LANDSCAPE INSTALLATION:

**1 - City Approval Required**

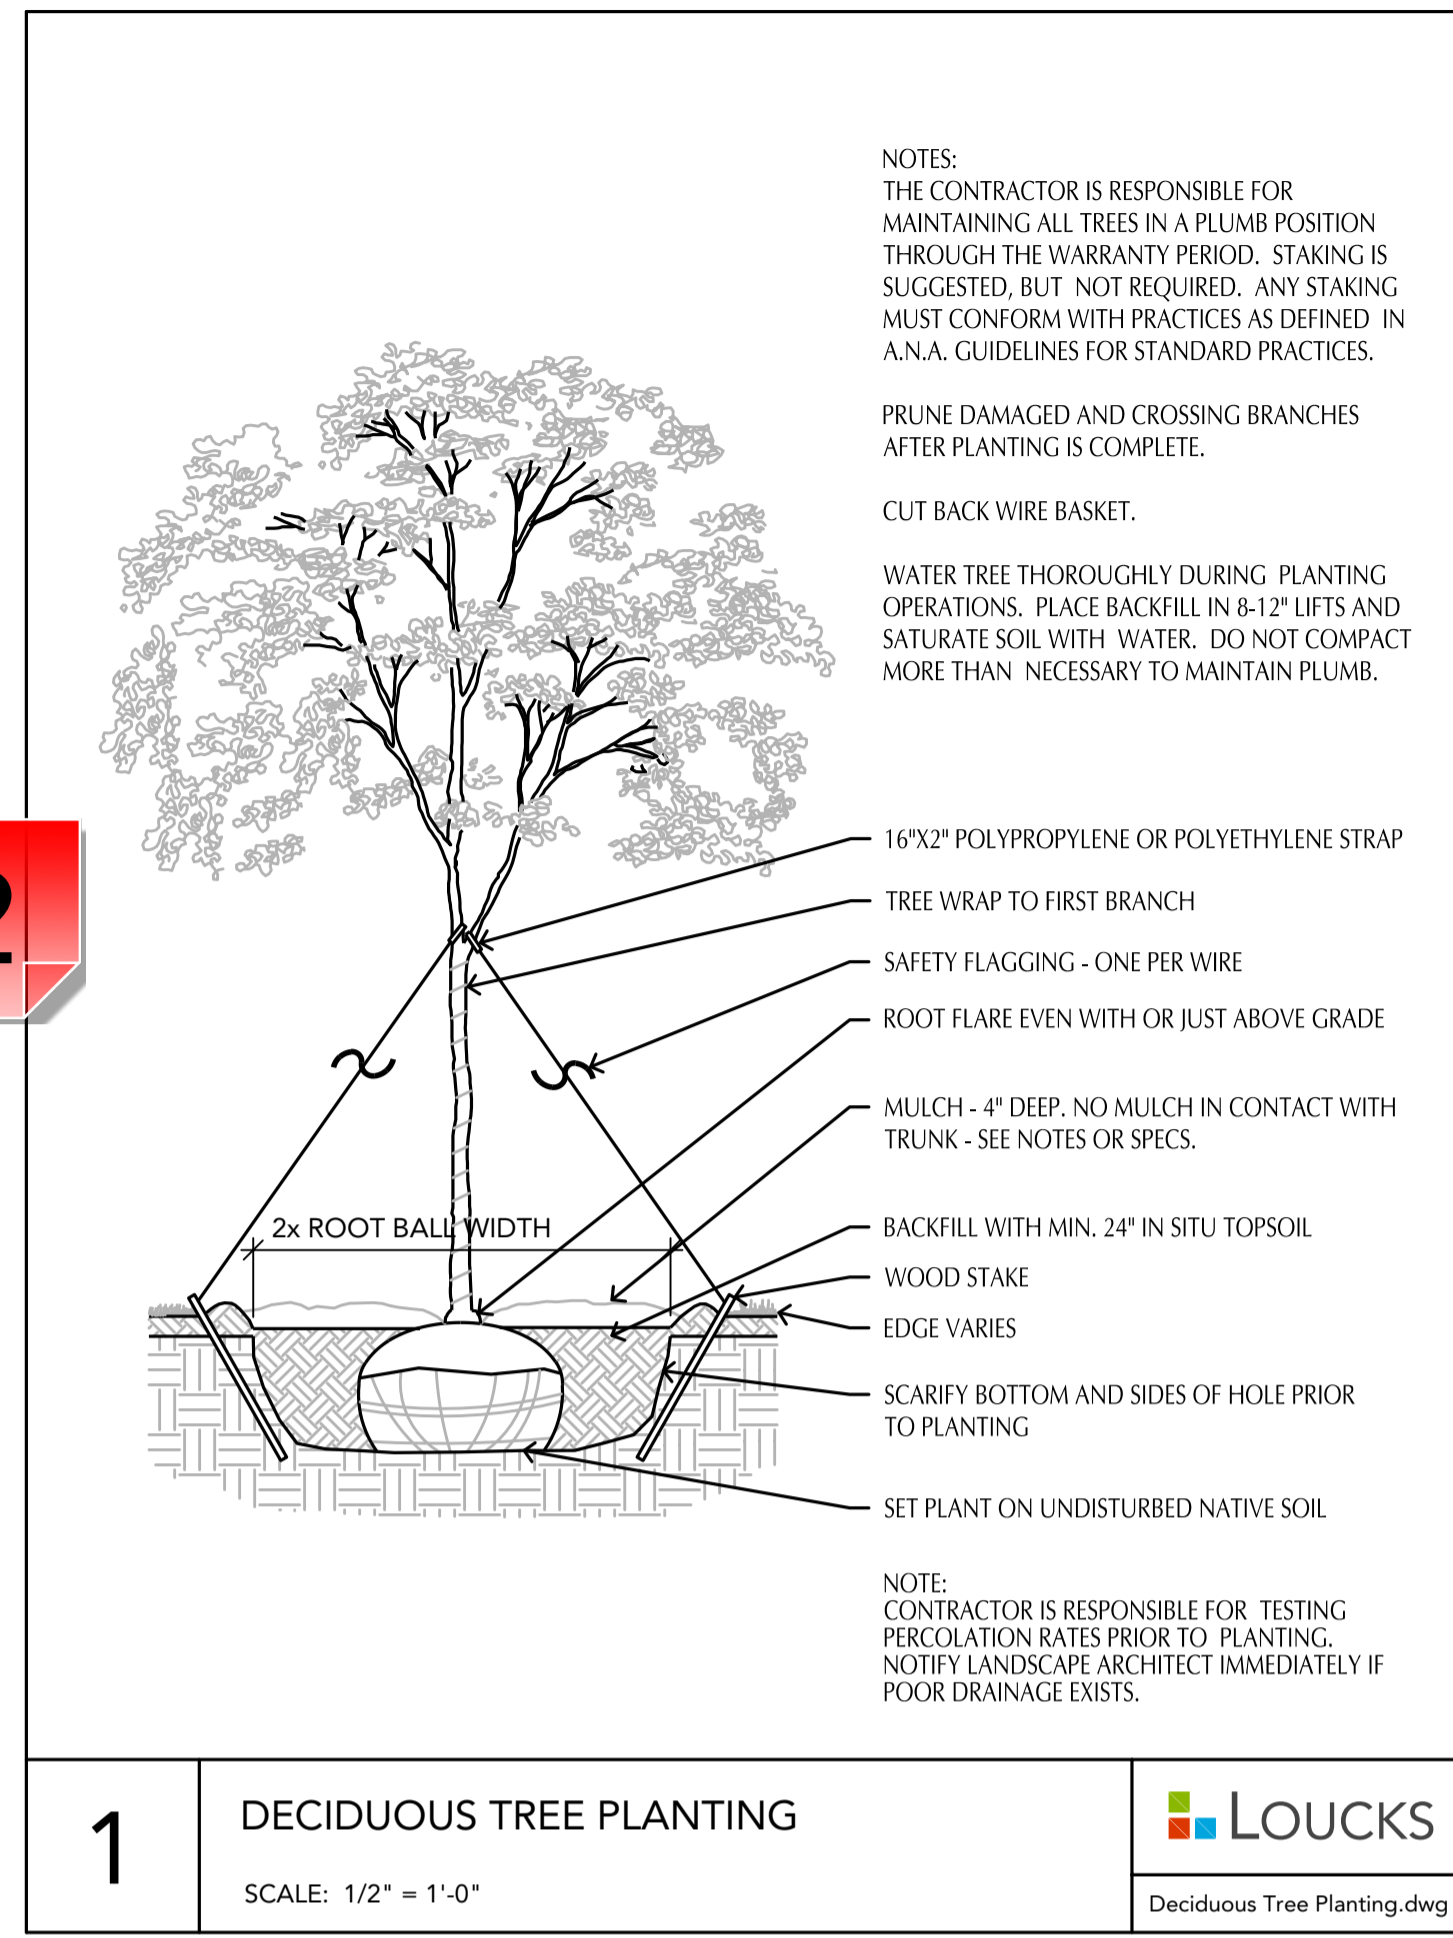
Modify this note to specify that any deviation from the approved species requires city approval prior to installation.

The Development Agreement will require a warranty period of 2-years from the date of landscape inspection approval by the city.

Any irrigation system installed shall contain a rain sensor and some form of water efficient technology such as a weather compensating smart controller. Modify note accordingly.

There is an existing irrigation line in place along Sunwood Drive. This irrigation line shall be used for the planter beds along Sunwood Drive (it shall not be used for internal site irrigation). Coordinate with City Staff for use of this existing irrigation line.

All disturbed areas not otherwise improved with impervious surfacing, shall be finished with four (4) inches of topsoil with not more than 35% sand content. A topsoil inspection is required prior to installing sod and plantings.
